Radio, Phonograph and Tape Service Tips

Volume XXI Issue 1 January 30, 1970

RS-225B Amplifier Chassis Layout

Chassis Layout—Wiring View RS-225B

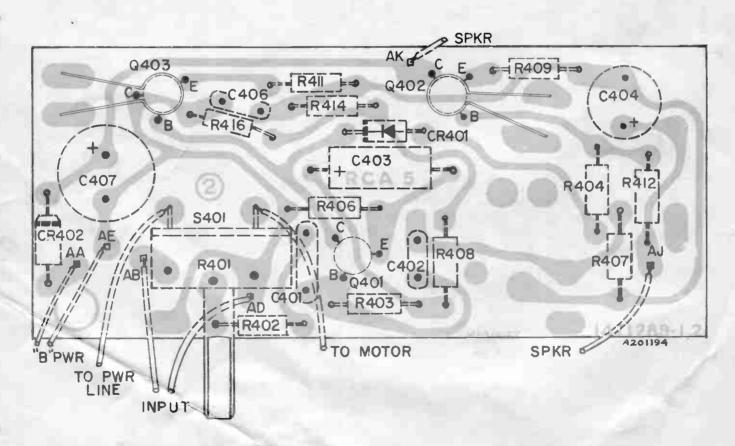
The chassis layout wiring view has been modified to show components with dotted outline. CR401 diode polarity has been polarized to agree with schematic.

Care should be exercised in replacing CR401 to insure correct circuit operating potentials.

Chassis Layout—Wiring View RS-250A

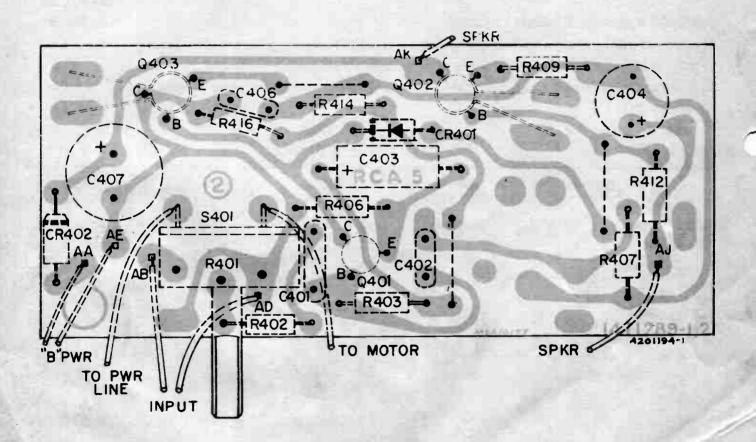
The chassis layout wiring view has been modified to show components with dotted outline.

CR401 diode polarity has been polarized to agree with schematic.

Care should be exercised in replacing CR401 to insure correct circuit operating potentials.
